In the Figures

REMARKS

Amendments to the Figures

FIG. 1A

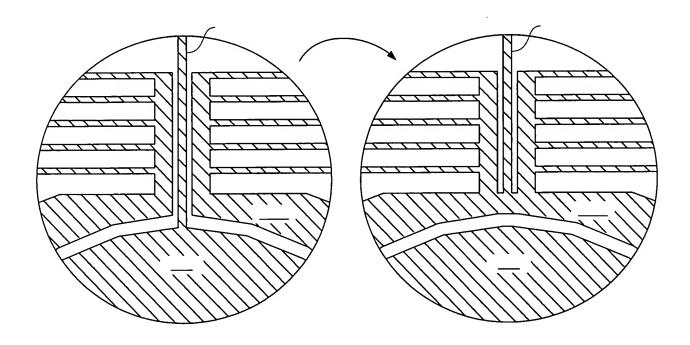
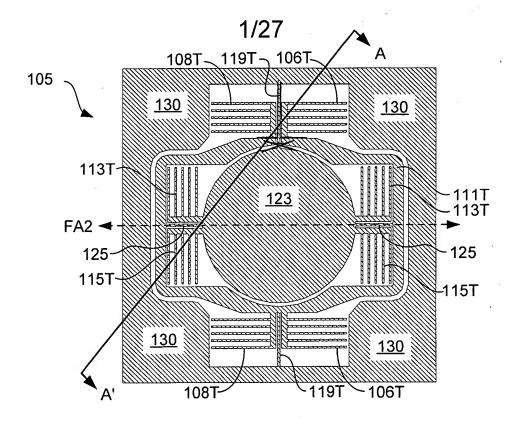
Please amend Figure 1 as indicated in red ink on the attached sheet. The amendment is difficult to illustrate in ink, so a substitute sheet is submitted herewith for the Examiner's consideration.

Applicants amended Figure 1, as shown in red ink on the attached sheet. The amendment is difficult to highlight in ink, so the amended portion is reproduced below for ease of review. The amendment is supported in Figure 1A (the other frame hinge 119T is correctly attached) and Figure 1B, which shows the bottom half 119B associated with top half 119T. No new matter is added.

FIG. 33A

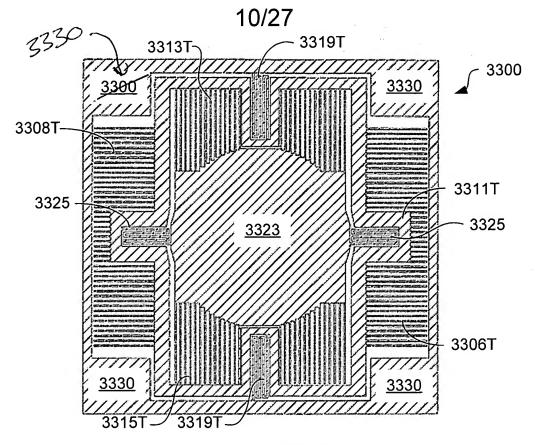
Figure 33A is amended to consistently number region 3330. The correction is obvious, and does not introduce new matter.
